Meeting Minutes Transmittal/Approval
Unit Managers' Meeting
200 Area Groundwater and Source Operable Units
1200 Jadwin, Richland, Washington
September 20, 2007

**DISTRIBUTION
UNIT MANAGERS' MEETING,
200 AREA GROUNDWATER SOURCE OPERABLE UNITS
September 20, 2007**

**Issue Resolution Meeting
Agreements and Issues List
September 20, 2007
200 Area Unit Managers' Meeting**

Attachment 2
New well 699-52-55A

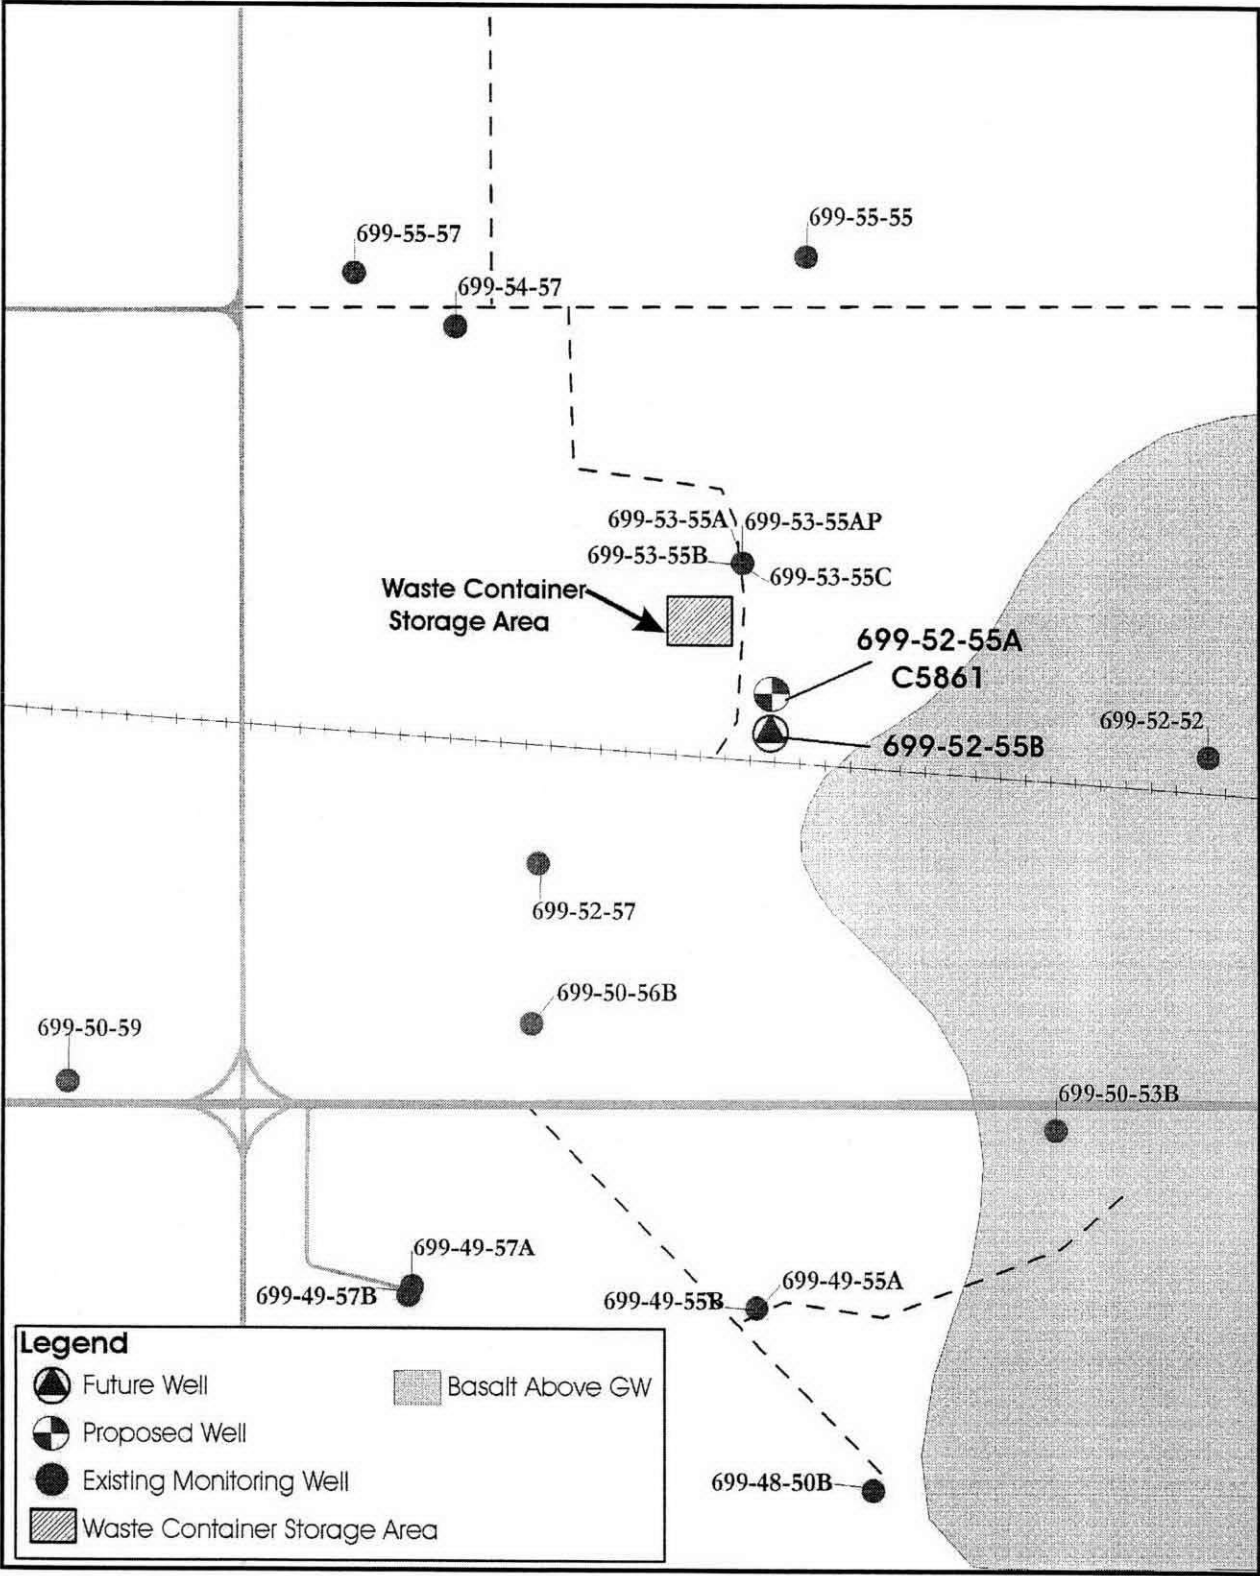
Change Number	Document Submitted Under Tri-Party Agreement Milestone	Date:	
TPA-CN-170	<u>N/A</u>	08/16/07	
Document Number and Title: DOE/RL-2003-30, Revision 2, <i>Waste Control Plan for the 200-BP-5 Operable Unit</i>		Date Document Last Issued: March 2004	
Originator: Rick Oldham		Phone: 372-2426 or 521-8633	
Description of Change: Update of Attachment 2 (Waste Container Storage Location) and Attachment 3A (200-BP-5 Operable Unit Groundwater Well Supplemental List).			
<p><u>B. Charboneau</u> and <u>R. Lobos</u> agree that the proposed change modifies an approved RL Lead Regulatory Agency</p> <p>workplan/document and will be processed in accordance with the Tri-Party Agreement Action Plan, Section 9.0, <i>Documentation and Records</i>, and not Chapter 12.0, <i>Changes to the Agreement</i>.</p> <p>Attachment 2 of the above referenced plan has been modified to add 2 new waste container storage locations for the two investigation wells (C5861 and C5852) planned for construction/installation in about late August.</p> <p>Attachment 3A (200-BP-5 Operable Unit Groundwater Well Supplemental List) of the above referenced plan has been modified to add 5 wells. Two wells are planned for construction/installation beginning about late August. Three wells are existing wells being added for sampling purposes.</p> <p>Note: The affected page numbers for the supplemental well list are pages 10 and 11. Two new pages are added to Attachment 2 to show the proposed well locations and the corresponding waste container storage areas.</p>

Justification and Impacts of Change:			
Revision 3 of the above referenced plan is in process but its review and approval will not be completed before construction of the above wells are scheduled to begin. The well list updates and waste container storage area additions made by this change will be reflected in Revision 3 of the waste control plan.			
Approvals:			
 RL Project Manager	<u>8/24/07</u> Date	<input checked="" type="checkbox"/> Approved <input type="checkbox"/> Disapproved	
 EPA Project Manager (BP-5 OU Lead)	<u>8/22/07</u> Date	<input checked="" type="checkbox"/> Approved <input type="checkbox"/> Disapproved

Figure 3

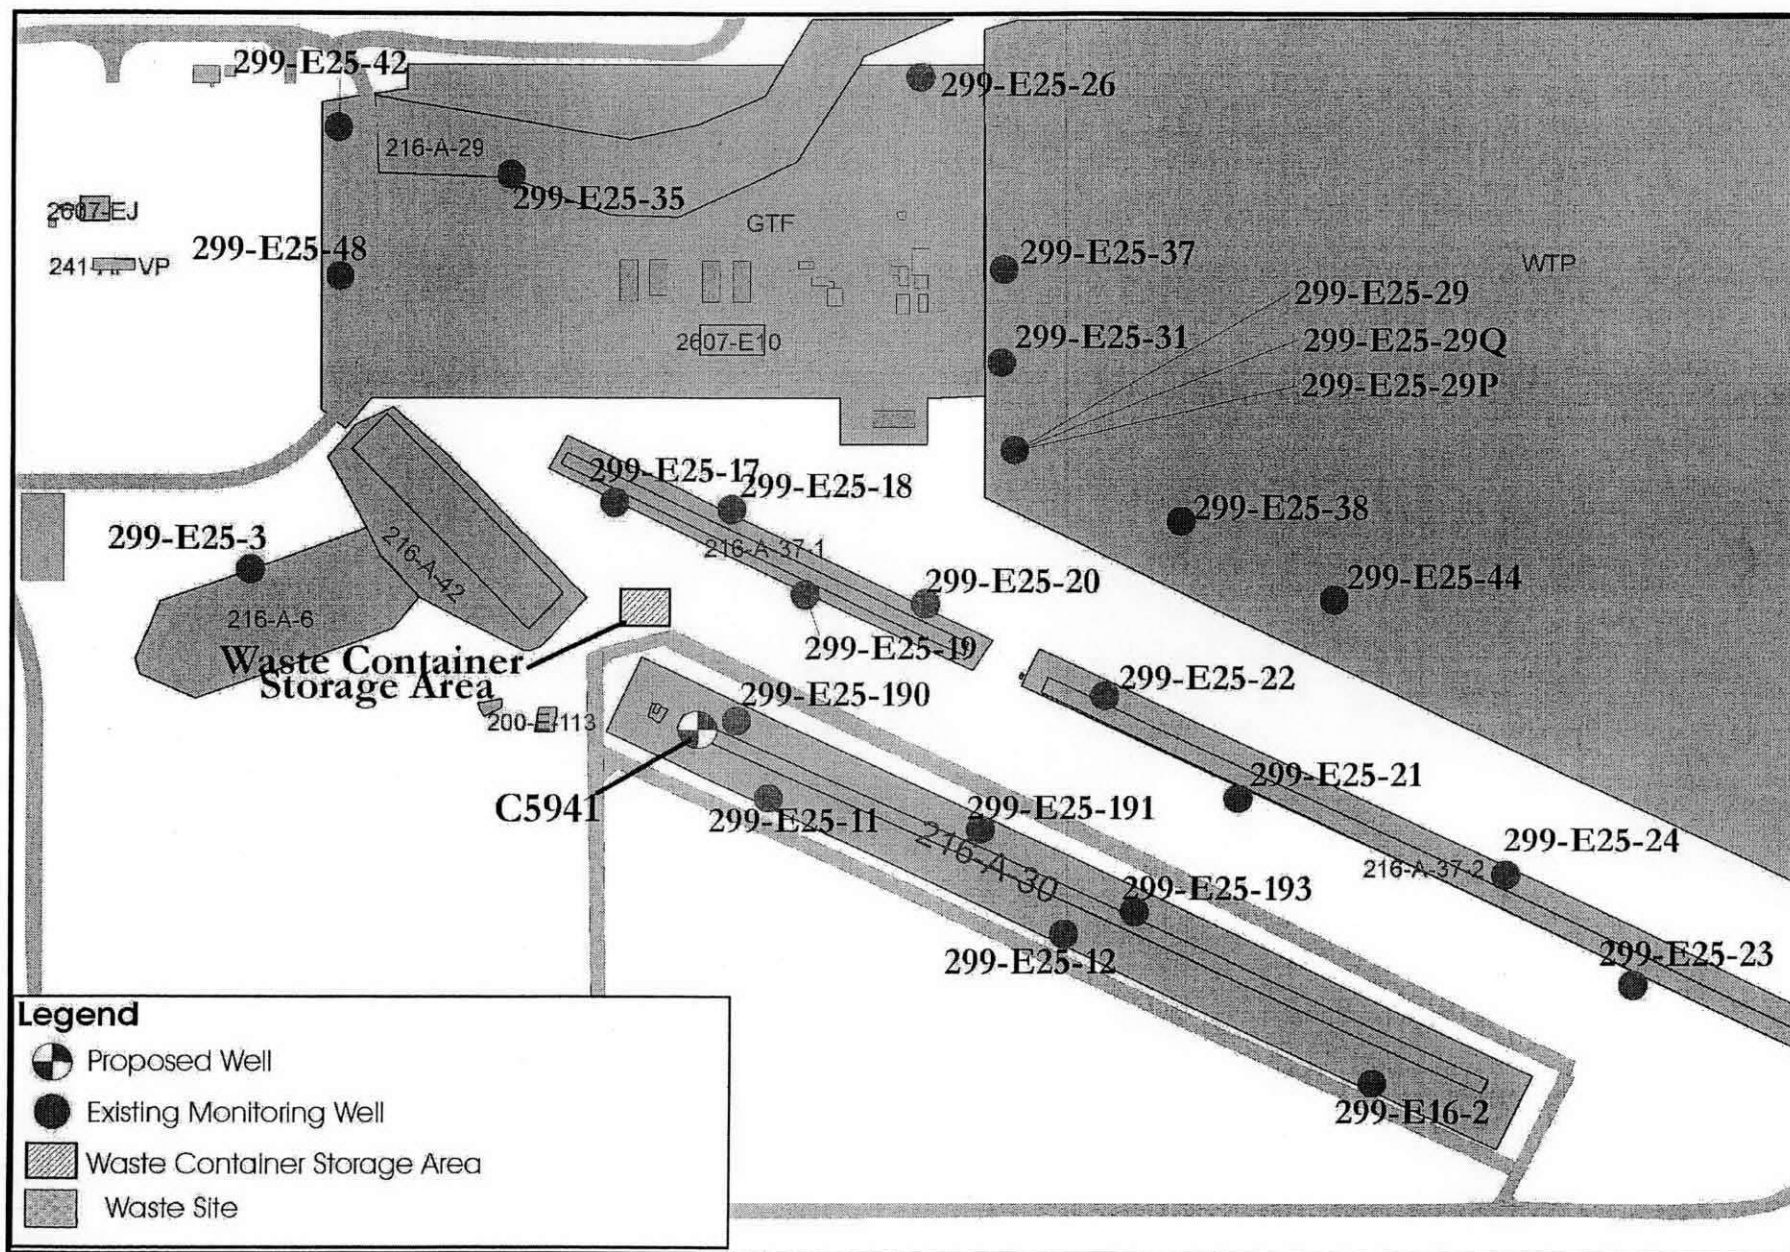
Change Number	Document Submitted Under Tri-Party Agreement Milestone	Date:	
TPA-CN-175	N/A	08/16/07	
Document Number and Title: WMP-24648, Revision 0, Waste Control Plan for the 200-CW-5, 200-CW-2, 200-CW-4 and 200-SC-1 Operable Units		Date Document Last Issued: June 2005	
Originator: Rick Oldham		Phone: 372-2426 or 521-8633	
Description of Change: Add Table 4 (200-SC-1 Borehole and Direct Push Well List). Add Figures 3 and 4 showing borehole, direct push and waste container storage area locations.			
<p><u>B. Charboneau</u> and <u>C. Cameron</u> agree that the proposed change modifies an approved RL Lead Regulatory Agency</p> <p>workplan/document and will be processed in accordance with the Tri-Party Agreement Action Plan, Section 9.0, <i>Documentation and Records</i>, and not Chapter 12.0, <i>Changes to the Agreement</i>.</p> <p>Table 4 provides a listing of the well identification numbers for the planned borehole at the 216-A-30 crib and the direct pushes at the 216-B-55 crib.</p> <p>Figure 3 provides the location of the proposed borehole at the 216-A-30 crib.</p> <p>Figure 4 provides the locations of the direct push wells at the 216-B-55 crib.</p>

Justification and Impacts of Change:			
The well list update and waste container storage area additions made by this change will be reflected in the next revision (Revision 1) of the waste control plan.			
Approvals:			
 RL Project Manager	8/22/07 Date	<input checked="" type="checkbox"/> Approved <input type="checkbox"/> Disapproved	
 EPA Project Manager (SC-1 OU Lead)	8/23/07 Date	<input checked="" type="checkbox"/> Approved <input type="checkbox"/> Disapproved
